BALZER
& ASSOCIATES
PLANNERS / ARCHITECTS
ENGINEERS / SURVEYORS

December 28, 2021

RE: Rugby Field Townhomes CUP - Revisions

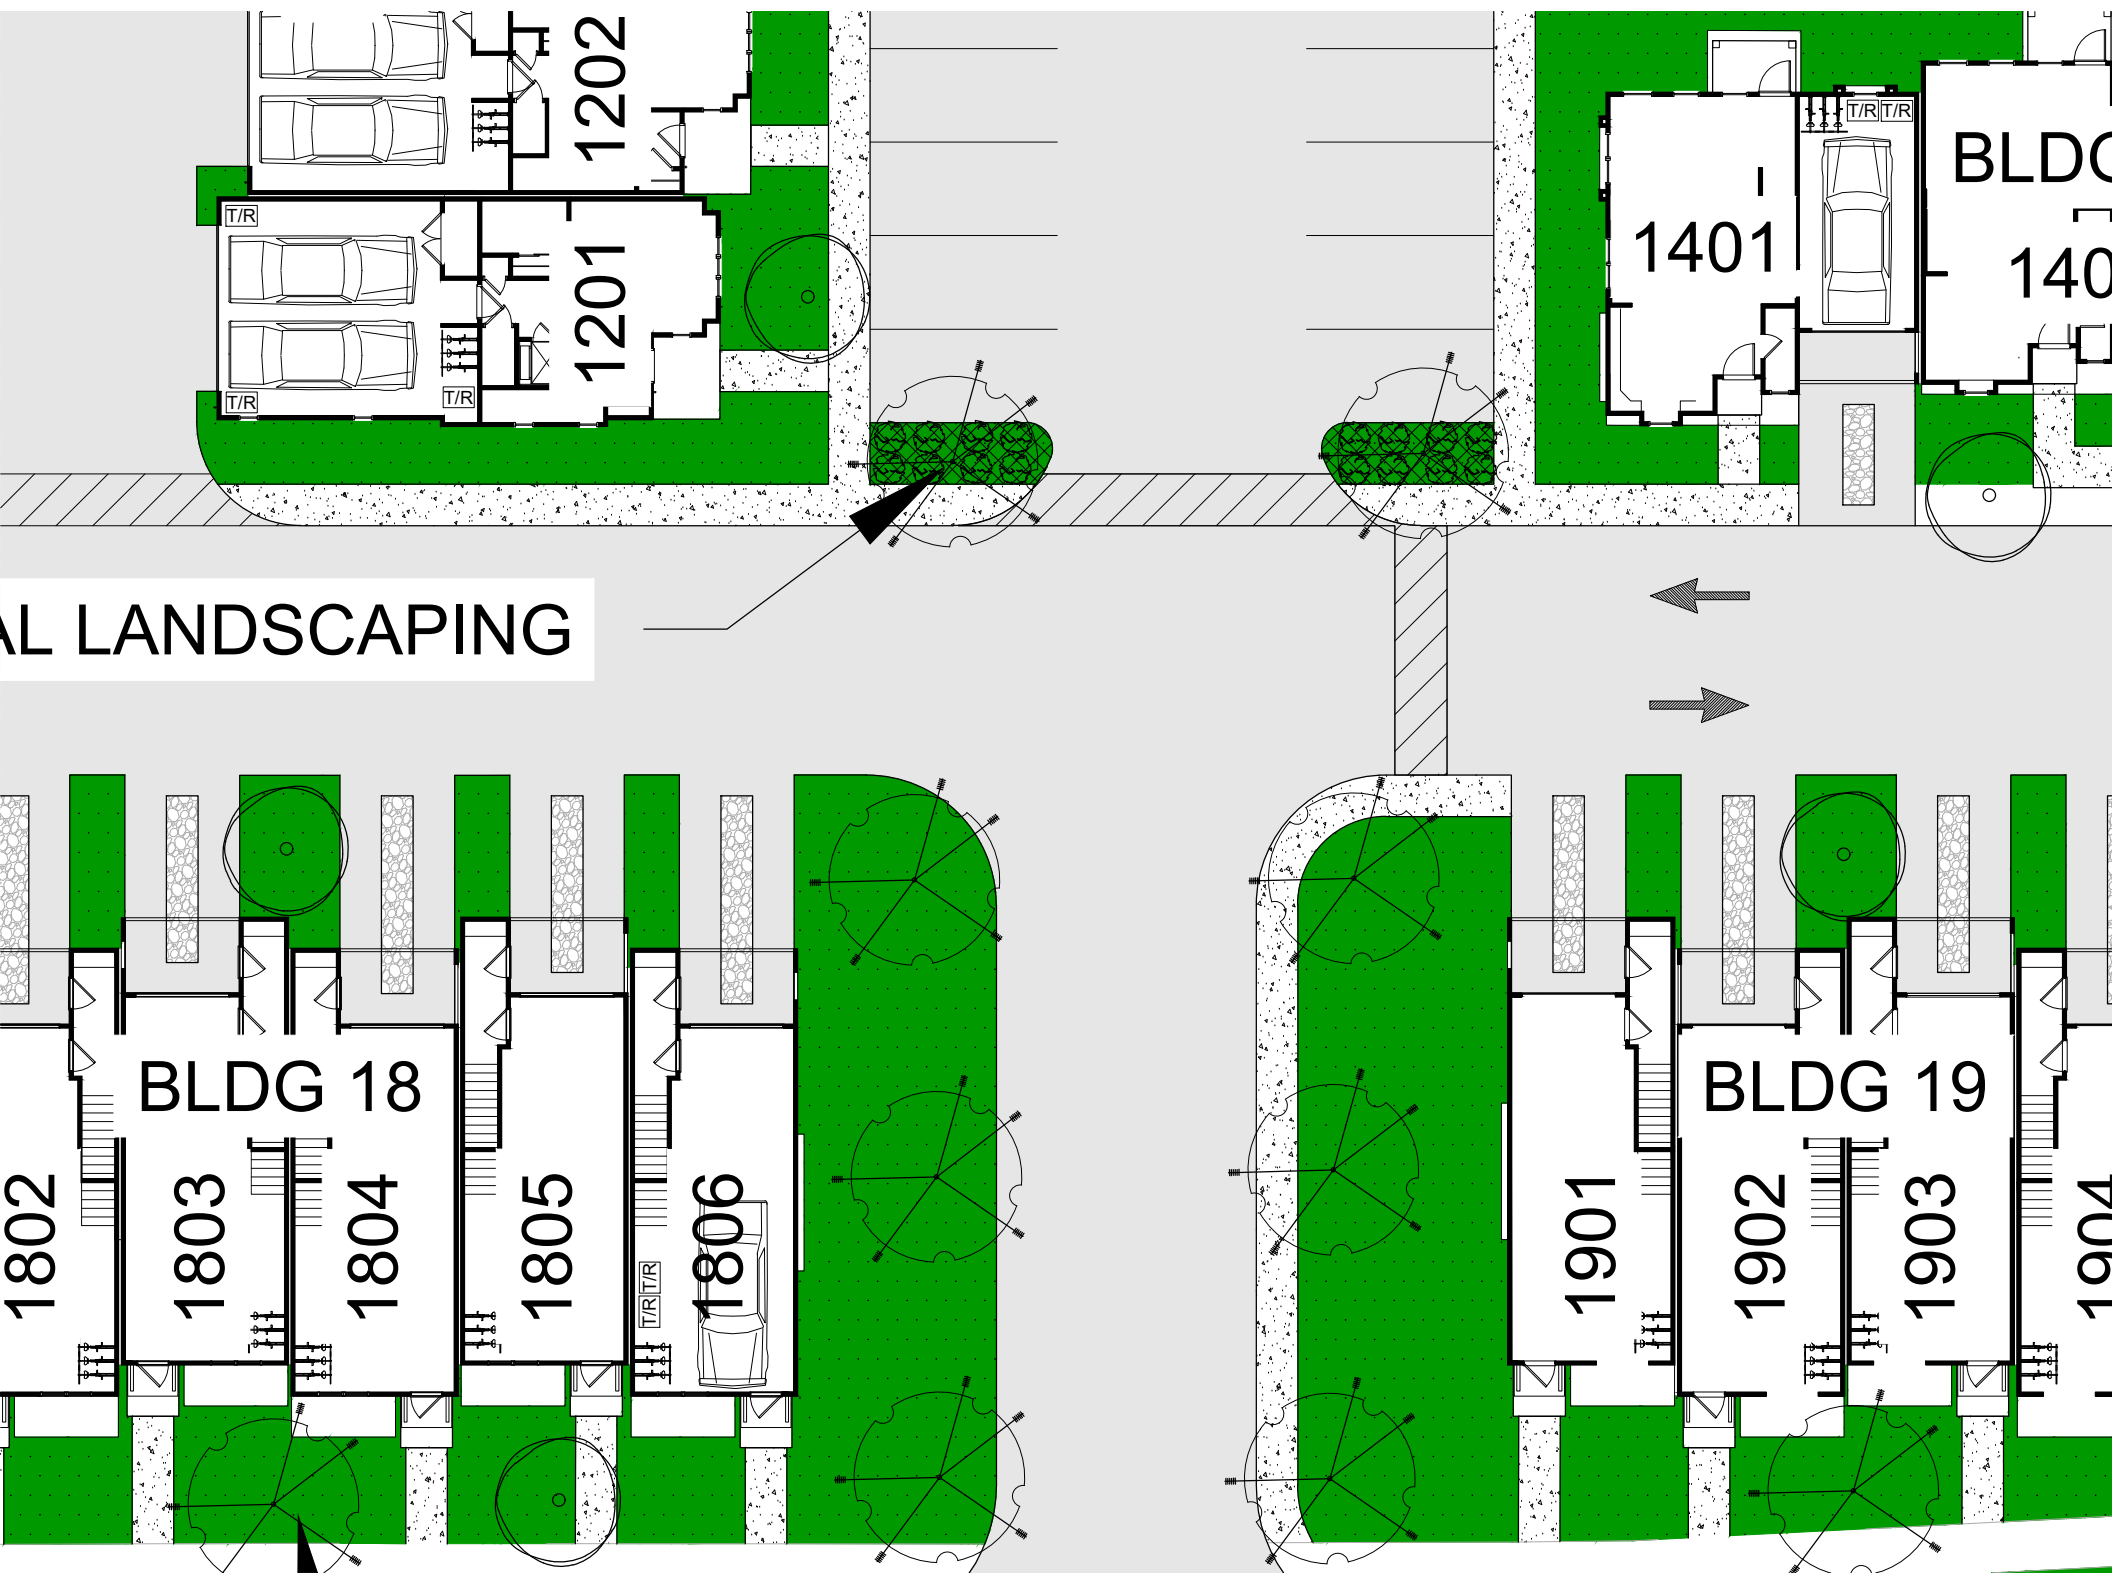
- 5) Drive Aisle Direction:
 - a. Alley access to garages for Buildings 9 & 10 and 11& 12 are 20' wide and have been designated as one way.
 - b. The 2 internal parking areas with 24 spaces each have been adjusted to a 20' drive aisle and designated as one way.
